To: T10 Technical Committee
From: Rob Elliott, HP (elliott@hp.com)
Date: 22 May 2006
Subject: 05-322r4 SAS-2 Wide port simultaneous connection recommendations

Figure 2 — Example simultaneous connection recommendations for wide ports

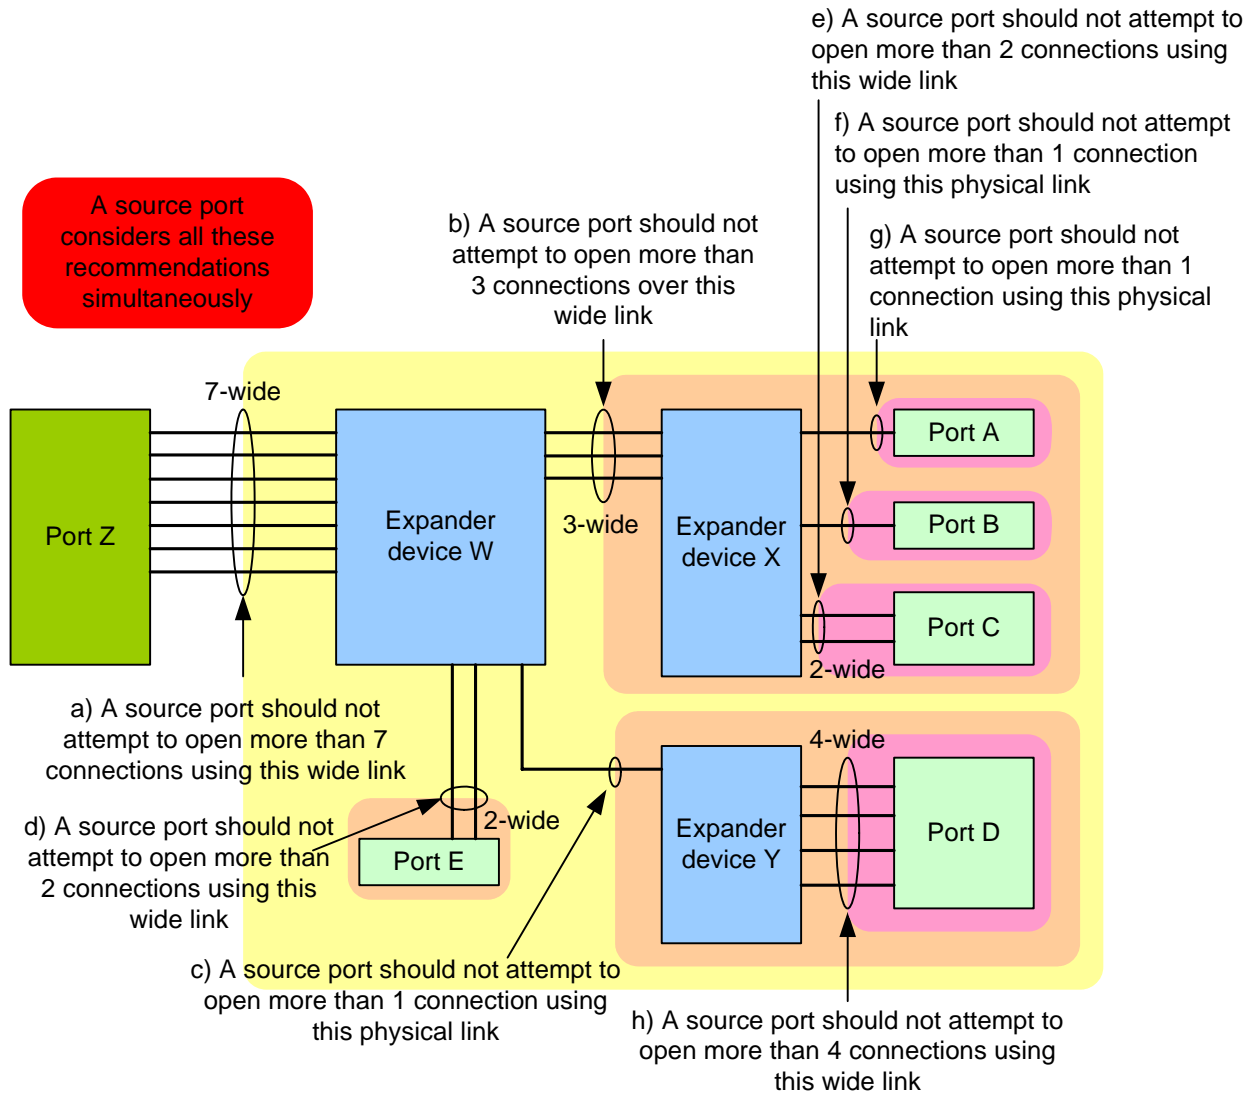
A wide port should not attempt to establish more connections to a destination port than the destination port width or the width of the narrowest physical link on the pathway to the destination port. A wide port should not attempt to establish more connections than the width of the narrowest common physical link on the pathways to the destination ports of those connections. Additional requirements for STP connection requests are defined in 7.17.6. Additional requirements for SMP connection requests are defined in 7.18.x.

In figure 2, some of the recommendations are combined as follows:

- a) Recommendations a), b), and e) together mean port Z should not attempt to open more than 2 connections to port C;

- b) [Recommendations a\), b\), e\), f\), and g\)](#) together mean that if port Z has 2 connections open to ports A, B, and X, it should not attempt to open more than 1 connection to port C. If it has 6 connections open to ports A, B, D, E, W, X, and Y, it should not attempt to open more than 1 connection to port C and
- c) [Recommendations a\), c\), and h\)](#) together mean port Z should not attempt to open more than 1 connection to port D. If it has a connection open to port Y, it should not attempt to open another connection to port D until the first connection is closed.

Figure 3 — Example simultaneous connection recommendations for an expander device

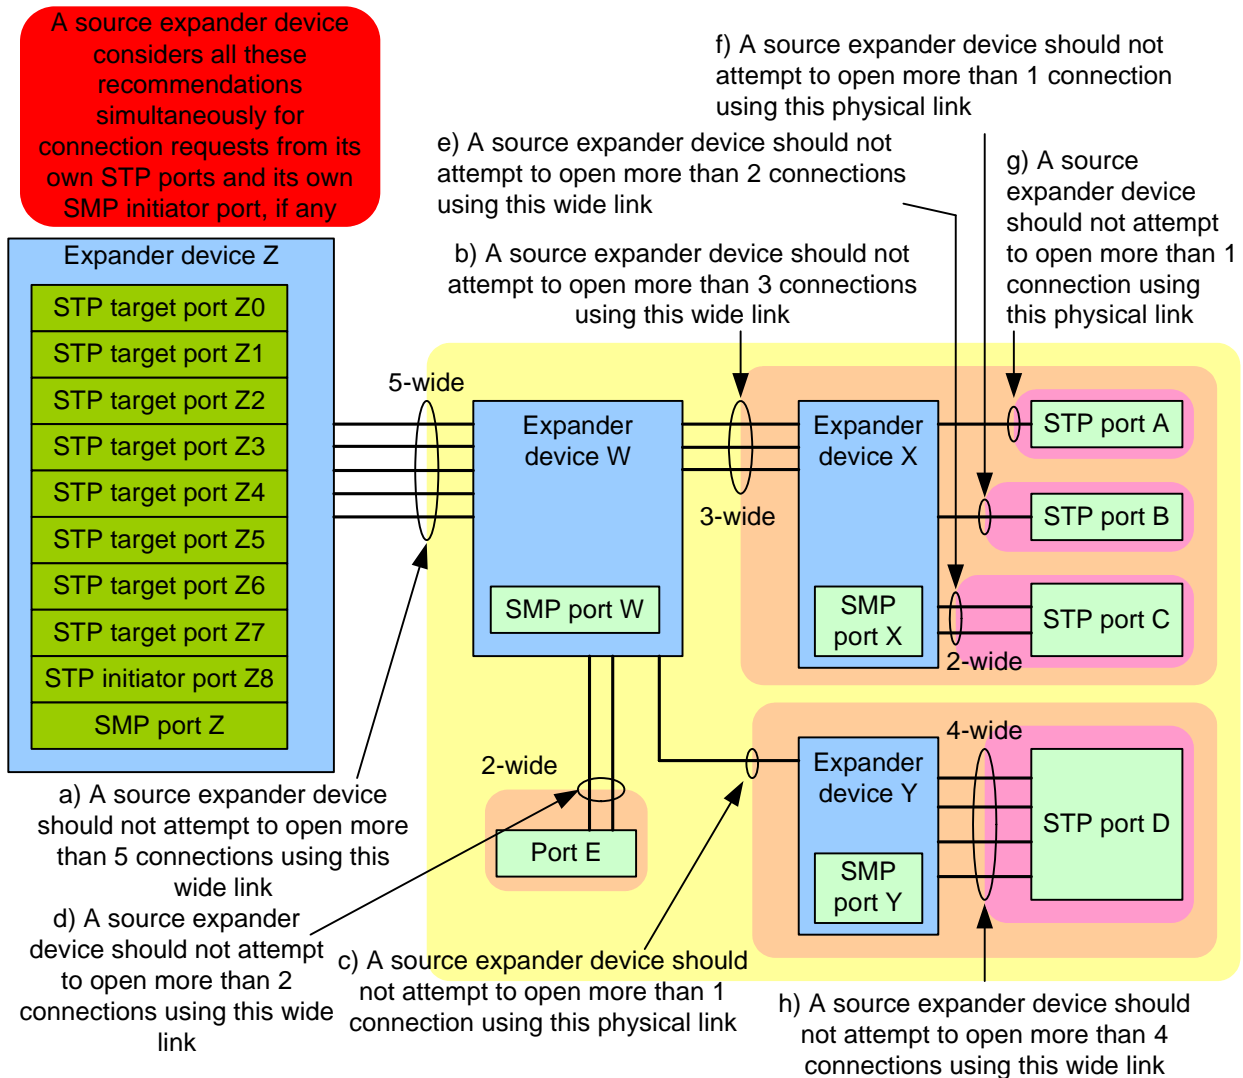
An expander device should not allow its STP ports (e.g., the STP target ports in STP/SATA bridges and any STP initiator ports in the expander device) to attempt to establish more connections to a specific destination port than the destination port width or the width of the narrowest physical link on the pathway to the destination port. This does not apply to connection requests being forwarded by the expander device.

An expander device should not allow its STP ports (e.g., the STP target ports in STP/SATA bridges and any STP initiator ports in the expander device) to attempt to establish more connections than the width of the narrowest common physical link on the pathways to the destination ports of those connections. This does not apply to connection requests being forwarded by the expander device.

In figure 3, some of the recommendations are combined as follows:

- a) Recommendations a), b), and e) together mean expander device Z should not attempt to open more than 2 connections to port C;
- b) Recommendations a), b), e), f), and g) together mean that if expander device Z has 2 connections open to ports A, B, and X, it should not attempt to open more than 1 connection to port C. If it has 4 connections open to ports A, B, D, E, W, X, and Y, it should not attempt to open more than 1 connection to port C; and
- c) Recommendations a), c), and h) together mean expander device Z should not attempt to open more than 1 connection to port D. If it has a connection open to port Y, it should not attempt to open another connection to port D until the first connection is closed.
